**City of Oakley**  
**ADDENDUM NO. 1 to contract documents for**  
**LAUREL ROAD AND ROSE AVENUE INTERSECTION IMPROVEMENT**  
**AND SIGNALIZATION PROJECT, CIP # 191**

**BID OPENING DATE: January 17, 2019 2:00 PM**

Notice is hereby given that the following clarifications and revisions are made to the above referenced contract documents:

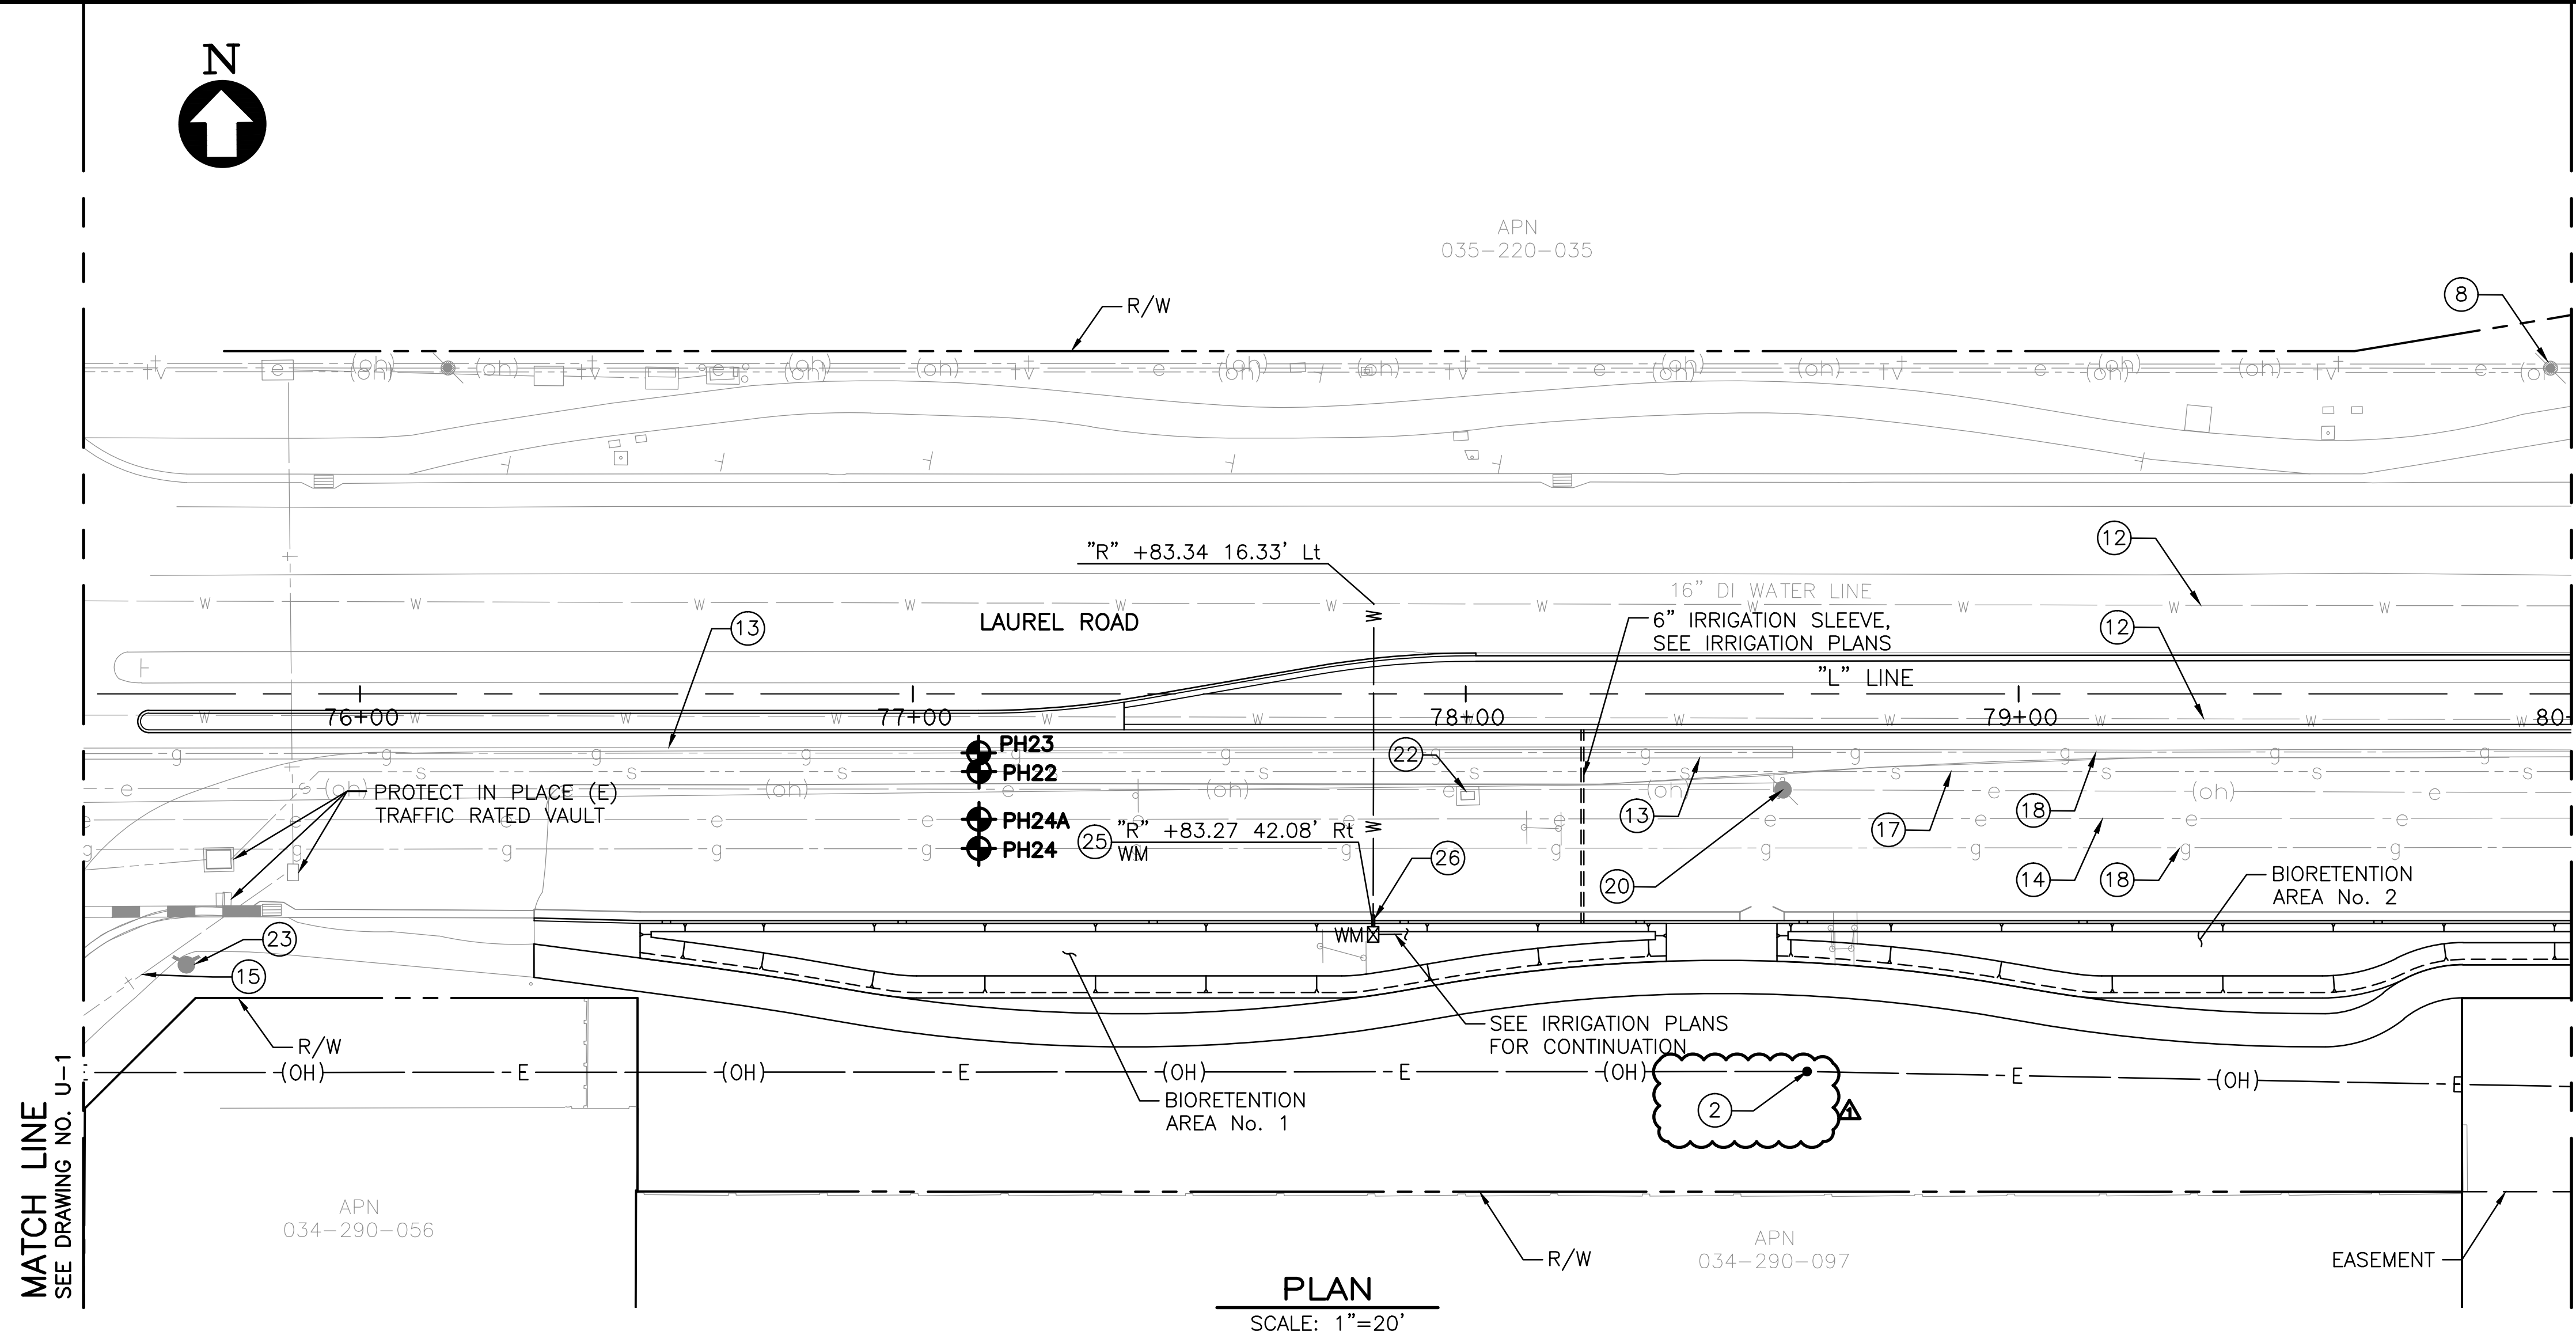
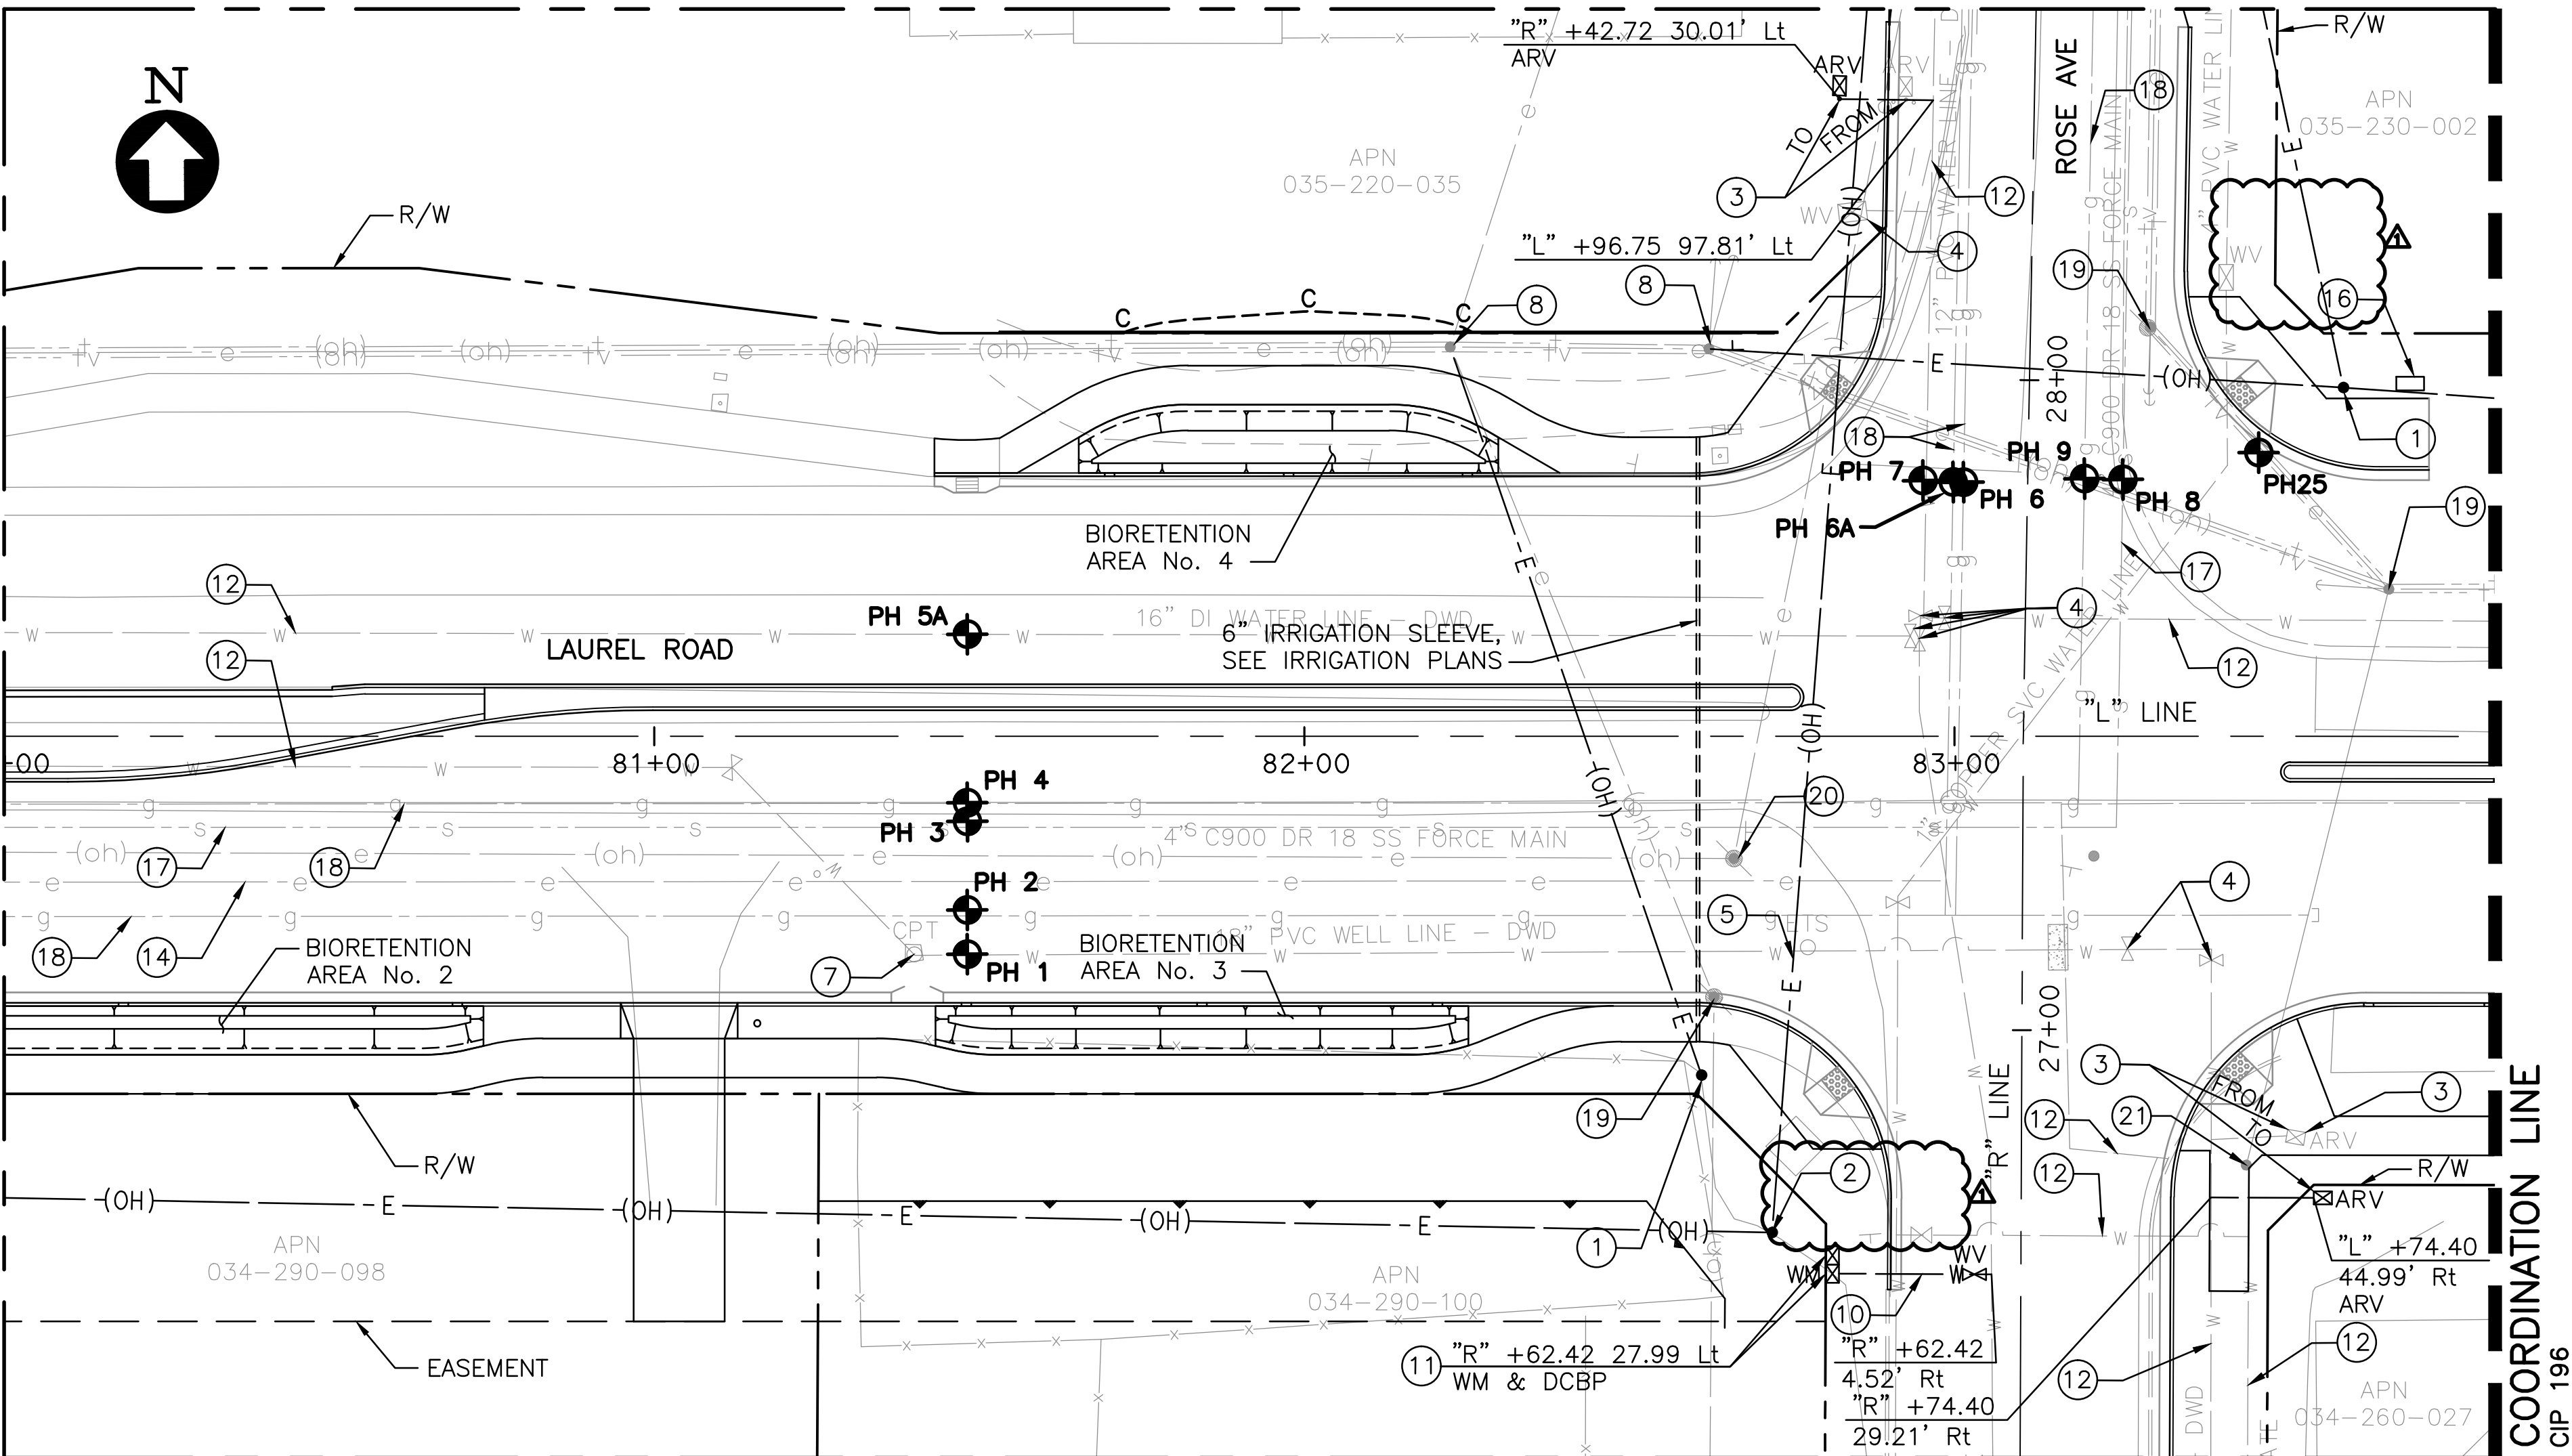
Updated Sheets CD-3, Q-1, U-1 thru U-6, E-1 and E-2
